World Forum for Harmonization of Vehicle Regulations

Working Party on Passive Safety

Forty-eighth session

Report of the Working Party on Passive Safety on its forty-eighth session

Paragraph 6.2.1., amend to read:

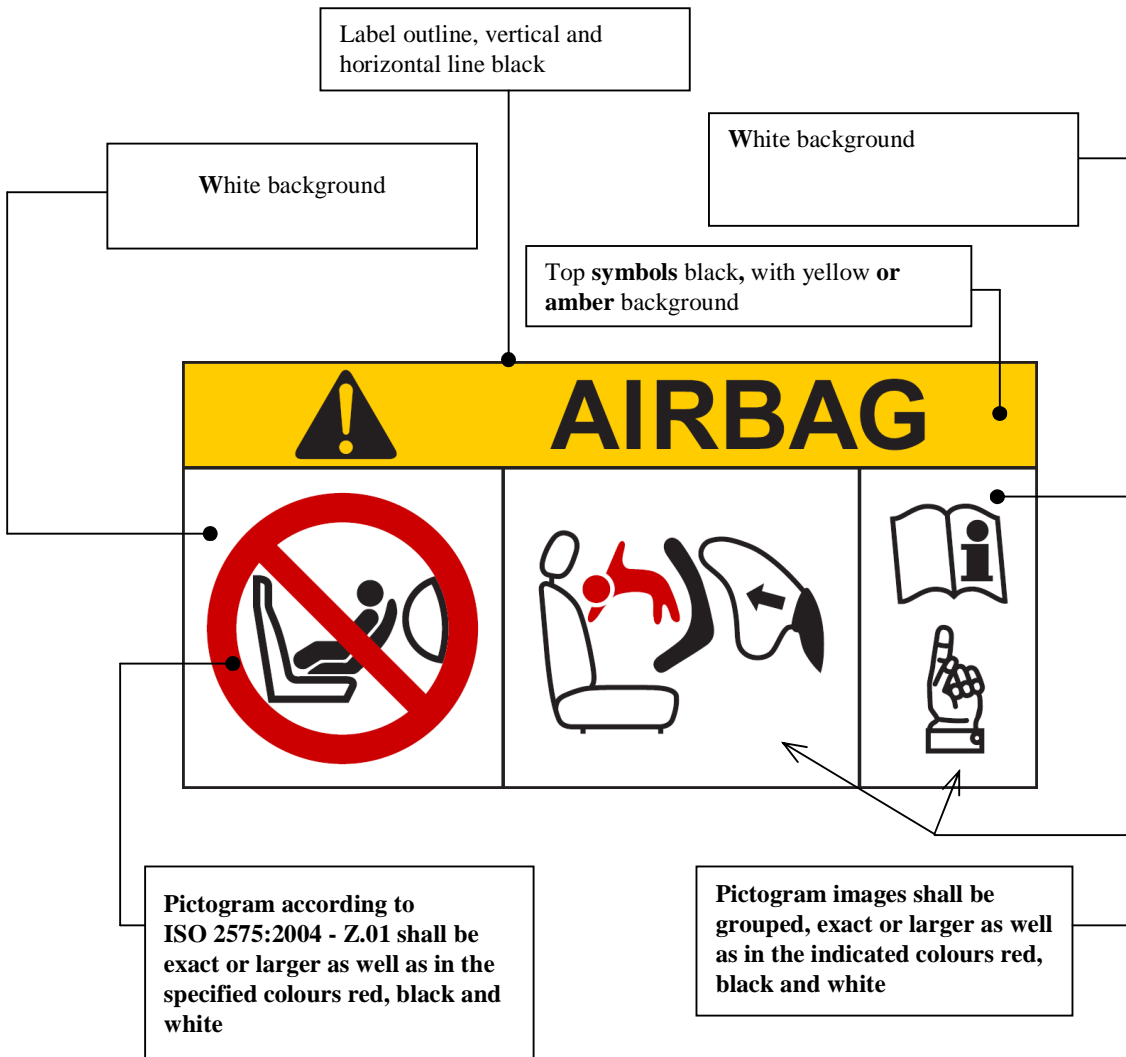
"6.2.1. As a minimum, this information shall consist of a label containing clear warning pictograms as indicated below:

Appendix 1, Figure 2, amend to read:

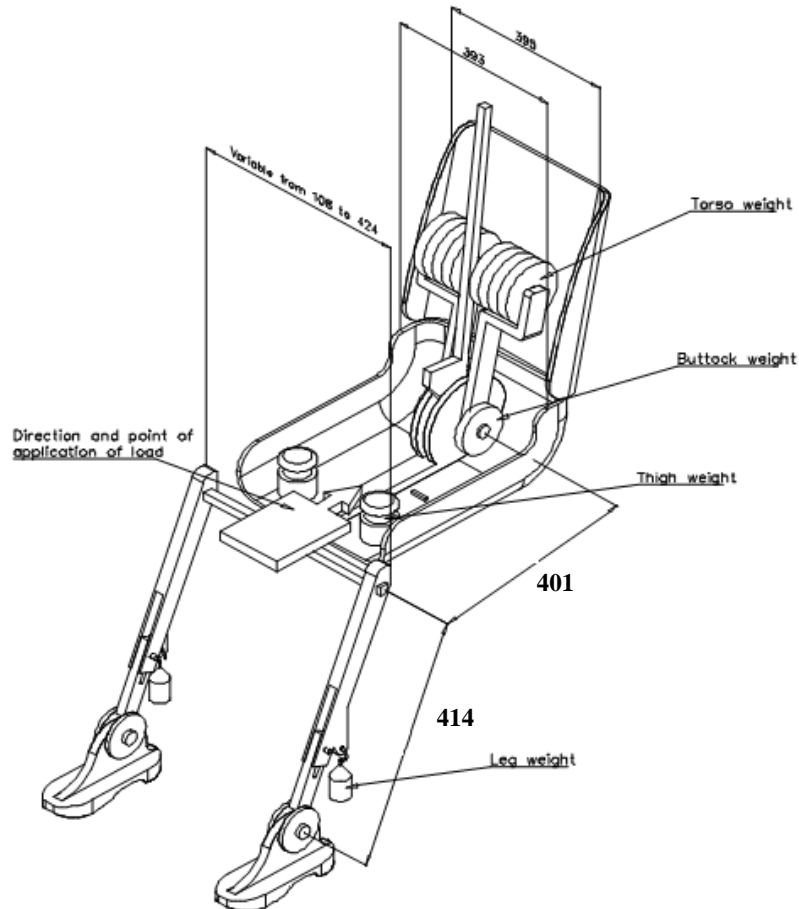
"2.2.4.4. *Class A:* Vehicles designed to carry standing passengers; a vehicle of this class has seats and may have provision for standing passengers **and having a capacity not exceeding 22 passengers in addition to the driver.**

2.2.4.5. *Class B:* Vehicles not designed to carry standing **and having a capacity not exceeding 22 passengers in addition to the driver.**"
